UNITED STATES PATENT AND TRADEMARK OFFICE

APPLICATION NO.	FILING DATE	FIRST NAMED INVENTOR	ATTORNEY DOCKET NO.	CONFIRMATION NO.
09/961,391	09/25/2001	Kenneth J. Carstensen		5498

Office Action Summary

DETAILED ACTION***Response to Election***

Fig. 2

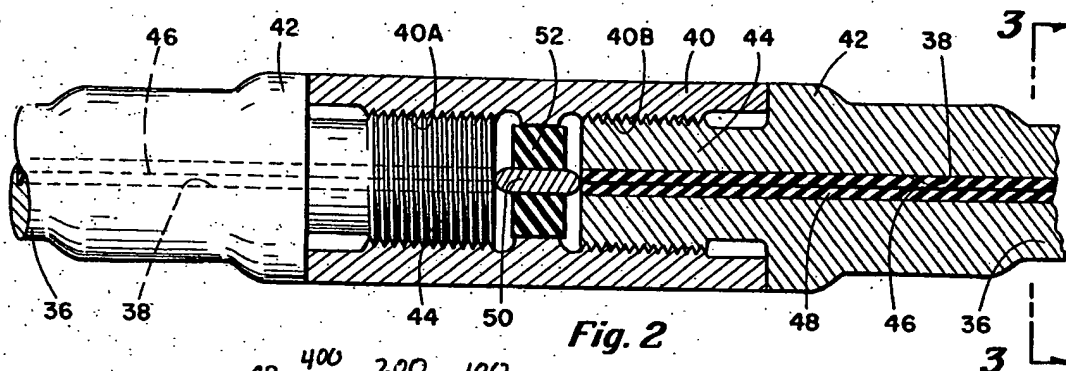
Regarding claim 1, Palone discloses (figs.2, 4) a connection for sucker rods used in strings in petroleum wells comprising: a pair of sucker rods (36), each having a pin end (44) with an end face (100) and at least an adjacent male threaded section (200); a coupler (40) having at least two interior female threaded sections (40A, 40B) receiving the male threaded sections of the pin ends, wherein the pin ends of the sucker rod includes coupler engagement members (42) spaced apart from the end faces; and the pin ends are dimensioned in length relative to the coupler to provide compressional engagement between opposing pin ends (via 58) when the male and female threaded sections are matingly inserted to a preselected penetration in the coupler.

As to claim 18, Palone discloses a connection for sucker rods used in pumping in oil well installations, comprising: a sleeve coupling (40) with an interior female threaded surface (40A, 40B) and having end walls of given radial dimension; a pair of sucker rod pin ends (44), each threaded into the coupling from a different end, each of the pin ends having a male threaded end portion (200) with an end face (100) transverse to the longitudinal axis of the rod, a transverse shoulder (42) spaced from the end plane by a pre-stress dimension, and an undercut pin neck (400) between the root thread of the male thread and the transverse shoulder, and a torque disk (58) having parallel planar faces (300) spaced apart by an axial distance and the torque disk
